ET90000 Double Pole Relay Upgrade

Now Standard on 4, 8, 12 & 16 Circuit Models

Update on ET90000 Series (4 Circuits and Above)

Jumper Pin Locations

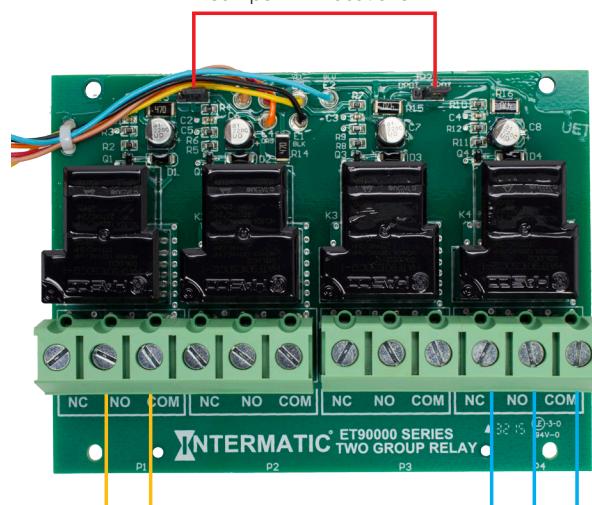
Jumper Pin Configurations

Jumper connecting pins 1 and 2 provide Double Pole (DPDT/DPST)

Jumper connecting pins 2 and 3 provide Single Pole (SPDT/SPST)

Using only the NO and COM Terminals provide **ST** (Single Throw)

Using only the NO, NC and COM Terminals provide **DT** (Double Throw)
